SERVICE BULLETIN

APPLICABILITY: 2017-19MY Impreza

NUMBER: 07-140-18

SUBJECT: DTC U0284, Additional Diagnostics Added

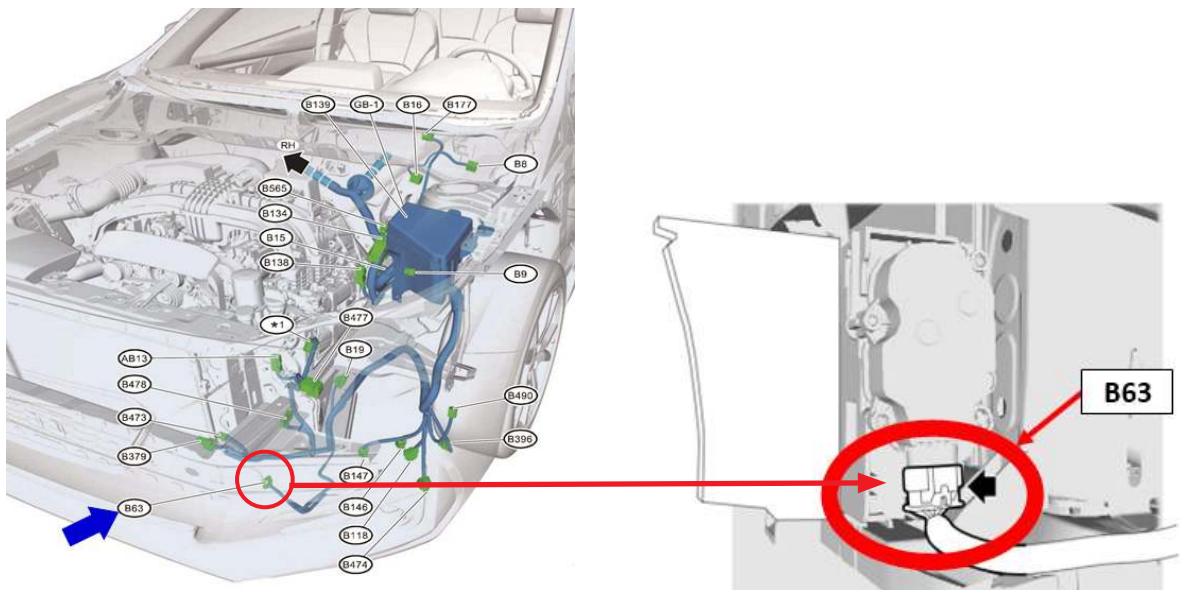
The AGS harness connector **B63** is located at the end of the AGS assembly in the l/front as shown below.
